Ghostbusters Flasher #129

Problem:

The +5 volt source supplying the "Left Scoop" Flasher #129 intermittently shorts to the metal ball guide rail located underneath it.

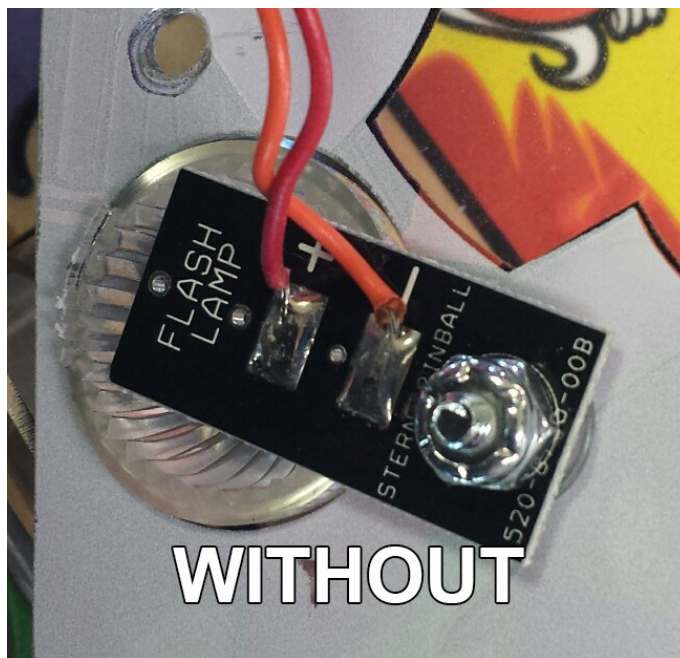
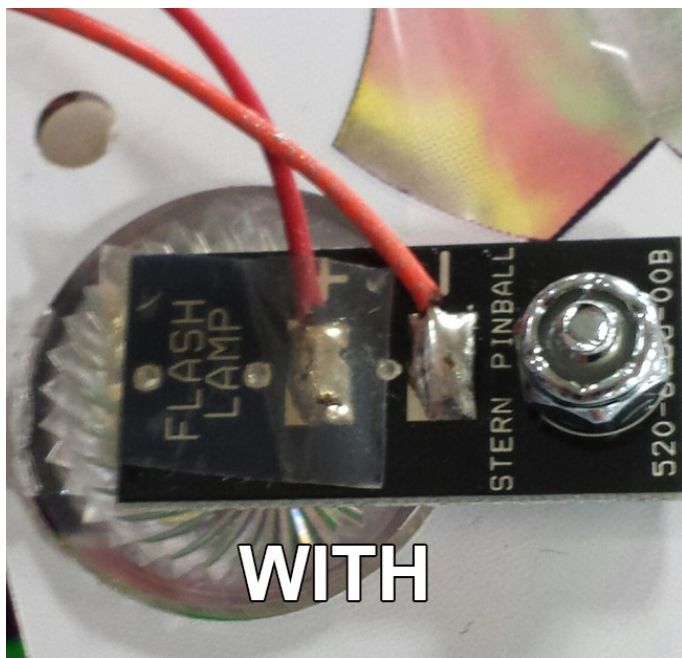
Flip Plastic #05 over in order to inspect the LED flasher PCB. The LED flasher PCB should have a non-conductive Mylar strip or fiche paper protecting the backside of the board.

If your LED flasher is missing the protective Mylar or fiche paper, contact Stern Pinball Inc. at 1-800-KICKERS or Parts.Service@sternpinball.com to receive service kit 502-7033-00.
